CITY OF THORNTON, COLORADO

**THORNTON WATER TREATMENT PLANT AND
DISTRIBUTION SYSTEM AUTOMATION PROJECT**

PROJECT NO. 203677

**ADDENDUM NO. 2
TO THE
CONTRACT DOCUMENTS**

CITY OF THORNTON TTP - PACKAGE 3 UPPER LEVEL PLAN AREA E PHOTOS	
project 98101	contract
drawing D209A	rev. 2
sheet file	of sheets

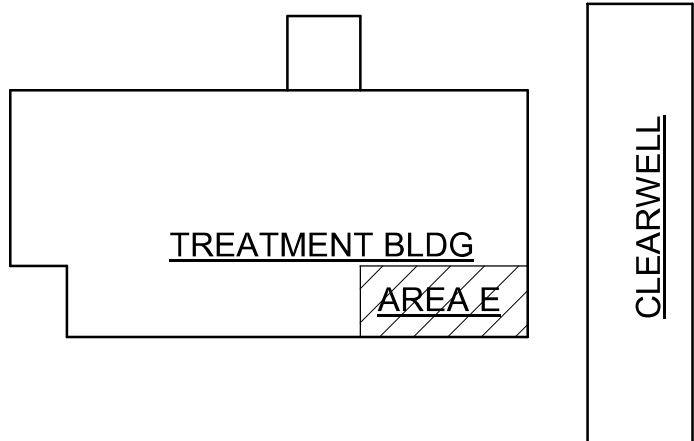
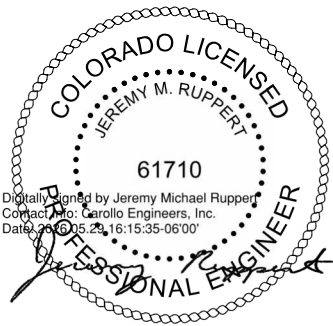
1 REPLACE EXISTING MANUAL BALL VALVE WITH ELECTRIC ACTUATED BALL VALVE. SODIUM HYPOCHLORITE BALL VALVES SHALL HAVE VITON SEAL, TEFLON SEAT, AND PVC BODY. SODIUM HYPOCHLORITE BALL VALVES SHALL BE SELF VENTING WHEN CLOSED. SUPPORT VALVE AND ACTUATOR SO PIPE IS NOT LOADED.
